# **Product Support Bulletin 2010-002**

## Maintenance of Way ~ Work Equipment Bulletin

DATE:	June 9, 2010		
SUBJECT:	Reinforced Spotting Cylinder Mounting – 34700033-570		
RATING:	DIRECTIVE (Action is required)	X ALERT (Potential Problem)	
	INFORMATION (Action is optional)	PRODUCT IMPROVEMENT (Enhance Product)	
MACHINE MODEL(S):	SP2R – Spike Puller		
SERIAL NUMBER(S):	310001-310132		
SUMMARY:	The mounting that supports the Workhead Spotting Cylinder could break off if the Spike Claws were to hit an obstruction while working. See Figure 1 on Page 2.		
OPERATIONAL IMPACT:	If the mounting breaks, the Workhead is free to move and could hit the cab and break the front window.		
ACTION:	The Spotting Cylinder Mounting must be reinforced with larger welds. Follow the instructions beginning on Page 3. <b>Make sure to follow all Lock Out-Tag Out Drocedures.</b> If the mounting itself is damaged or missing, a new mounting may be ordered through the Nordco Parts Department. Please call 1-800-647-1724 and order p/n 34700033-570. Machines with serial numbers above 310132 have been built with the reinforced mounting and will not have to be modified.

# REWORK SPOTTING CYLINDER MOUNTING ON SP2R FRAME

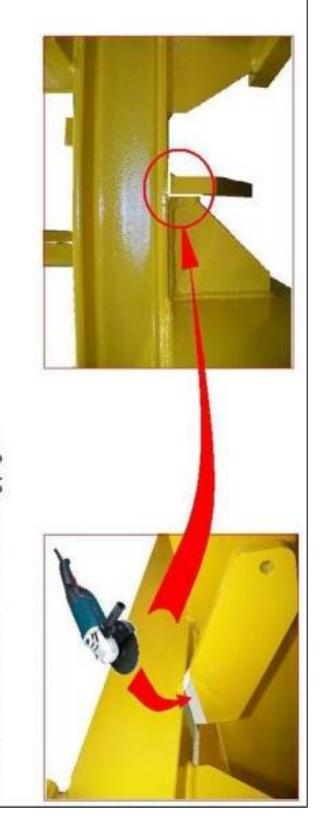
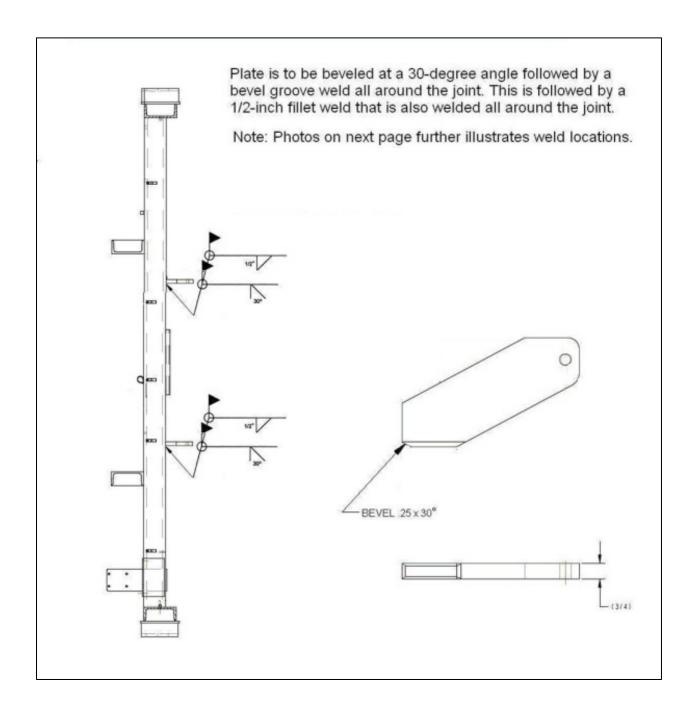
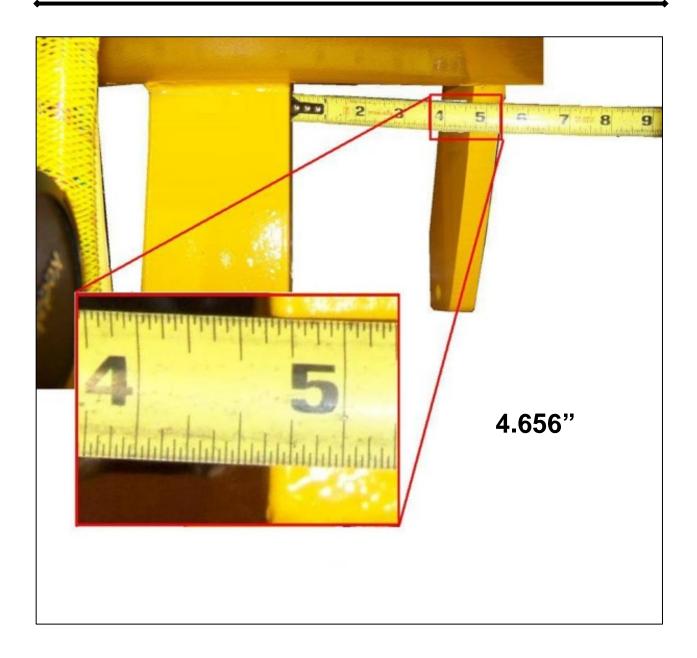
disc won't fit; use a cutoff wheel. Grind the weld flush with the frame rail, but do not over-grind. Clean and prep frame cylinder mounting bracket will separate from the frame. If you have to grind down the weld in a tight area, a grinding Grind out the majority of the weld so that when you strike it with a hammer, it will crack the leftover weld and the surface for welding.

The cylinder mounting bracket will be reused. Rework this bracket by adding a bevel at a 30deg angle. Then weld pracket to the frame as shown in the following pages.

Figure 1
98310008 Workhead Slider Stop Kit Installation Instructions

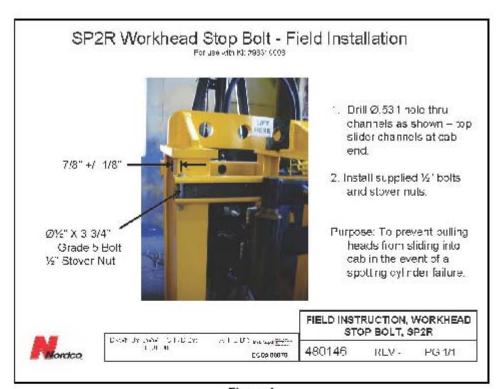
DATE:	June 30, 2009		
SUBJECT:	Workhead Slider Stop Bolt Kit – 98310008		
RATING:	DIRECTIVE (Action is required)	X ALERT (Potential Problem)	
	INFORMATION (Action is optional)	PRODUCT IMPROVEMENT (Enhance Product)	
MACHINE MODEL(S):	SP2R Dual Rail Spike Puller		
SERIAL NUMBER(S):	310001-310139 except 310131, 310132, 310137, 310138		
SUMMARY:	There have been reports of the lower front cab windows being broken by the Pulling Head if the Pulling Head Spotting Cylinder or its attachment bracket breaks. Installing this kit will limit the Pulling Head travel and prevent contact with the cab windows.		
OPERATIONAL			
IMPACT:	A broken lower front cab window can obstruct the operator's vision of the work area resulting in slower production.		
ACTION:	The 98310008 Workhead Slider Stop Bolt Kit contains 2 each of ½" x 3-1/4 Capscrew, p/n 2775356 and ½" Locknut (Stover Nut), p/n 3042025. Each kit will modify one complete machine. Installation involves drilling a 9/16" diameter hole through the cab end of the Upper Guide Channel on each side of the machine and installing the Capscrew and Locknut. See Figure 1 on Page 2 for drilling location Installation should take less than 1 hour. Be sure to follow all Lock Out/Tag Outprocedures before installing this kit.

Machines s/n 310131, 310132, 310137, 310138 and 310140 and higher have stops included as part of the machine frame and do not require this kit.		
WARRANTY:	None
